Notice 96-001

It has come to the attention of the Foundation from field reports that the following backflow prevention assemblies have exhibited low or inconsistent differential pressure readings across their check valves. Additionally, individual check valves have been discovered stuck in the open position, in a few assemblies.

1ST CHECK VALVE

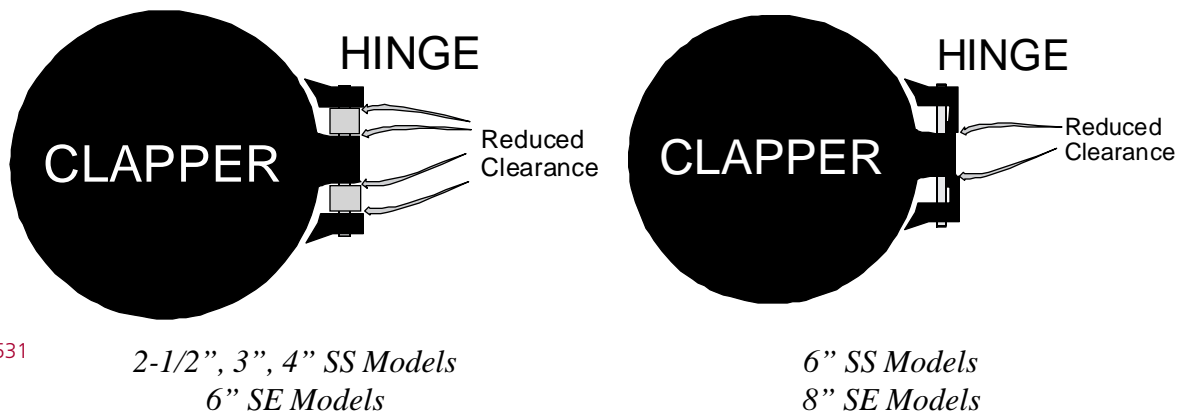
- The O-ring seal between the check valve seat ring and body has been changed. A larger diameter O-ring and larger groove in the check valve seat ring will provide a better seal.

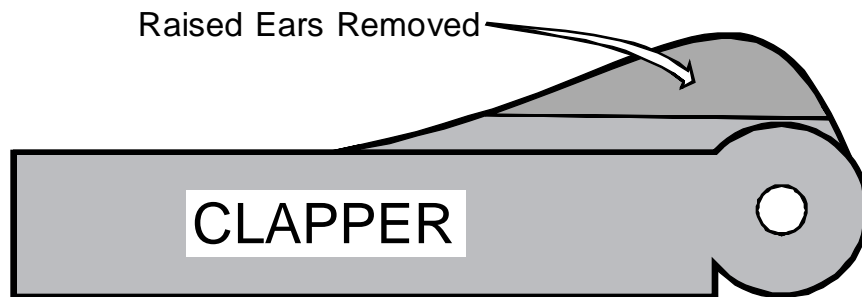
- Spacing at clapper hinge has been reduced to provide better alignment with the seat.
